System Unbalance Examples

Michael Paul, David Stover, and Heath Stewart

Issue

Figure 33B-1—PSE PI unbalance specification and E2EP2PRunb

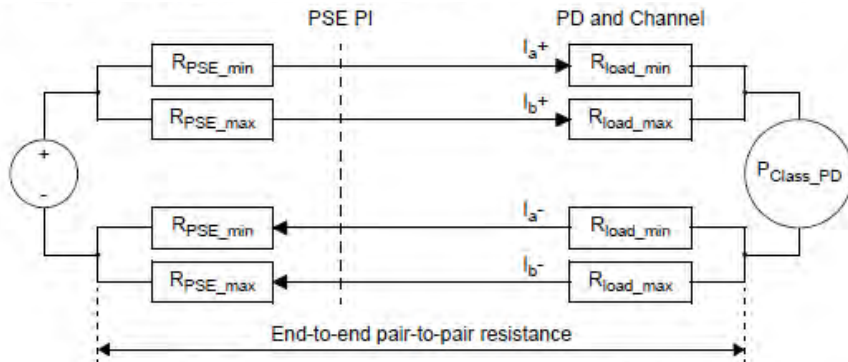
- System Unbalance calculated using the values and methods from Draft 2.1 is not in conformance with Icon-2p-unb from Table 33-19
- This presentation simply shows that the system is inoperable as defined
- The group needs to reach consensus on the path forward

Class 5 Low Channel Resistance Example

$$I_a = 558.6m \quad \leftarrow \text{Violates } I_{con-2p-usb}$$

- System Unbalance calculated using the values and methods from Draft 2.1 is not in conformance with Icon-2p-unb from Table 33-19
- Possible Fixes
 - Reduce PDs unbalance allocation
 - Increase system unbalance allocation
 - Reduce Pclass_PD (~1W)
 - Raise Vpse

Figure 33B-1—PSE PI unbalance specification and E2EP2PUnb

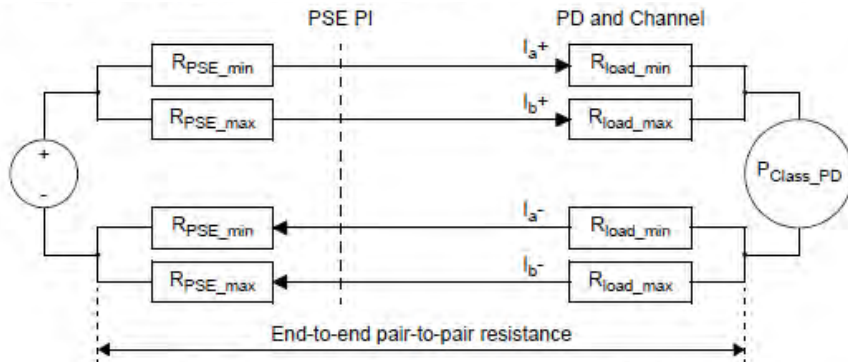
Class 6 Low Channel Resistance Example

$$I_a = 692.5m \quad \leftarrow \text{Violates } I_{con-2p-usb}$$
